*Proceedings of the Madras Government, Public Works Department,
14th April 1875.*

No. 356. Read the following endorsement of the Military Secretary, dated 22nd March 1875, No. 1,368 :—

In compliance with the request conveyed in your letter as per margin, I have the honor to submit, for the information of His Excellency the Commander-in-Chief, the following observations on the plan of the new hospital for Poonamallee.

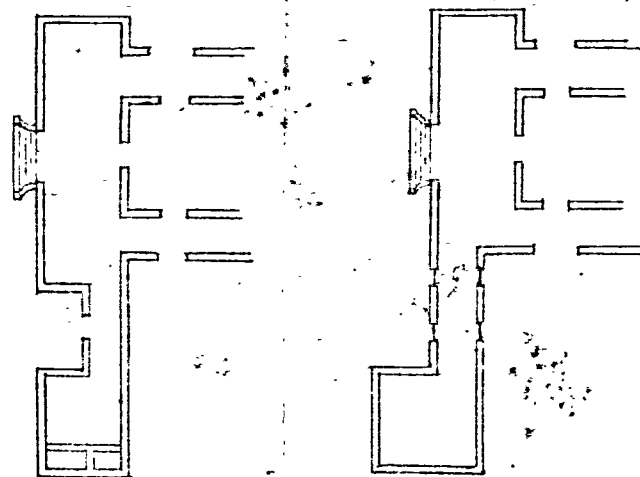
9. The latrines would be better placed, if, instead of being at right angles with the wards, they were at right angles with the further end of the verandahs, the latter being open, and the passage to the latrines having cross ventilation—*Vide* rough sketch appended. The lavatories should be quite clear of the verandahs.

10. The plan of ablution bath and latrine accommodation in the Artillery and Cavalry hospitals at Bangalore has been in use for several years and is found to answer well. I dare say it would be found as cheap to construct as the plan proposed, and, if so, it might be adopted in lieu of it.

11. Plans of the Bangalore hospitals are in your office; the only difference would be that accommodation should be provided at either end of the Poonamallee hospital instead of at one end only as at Bangalore.

12. It is presumed the hospital would be built side on to the prevailing winds.

13. It is calculated that the height of these wards is to be 20 feet, but, as regards the upper wards, it is not known whether this height is to the wall plate, or if the roof is included.

I do not object to the dimensions of these wards, but I would myself prefer half a foot more lineal space per bed, and wards 18 feet high, instead of the proportions proposed.
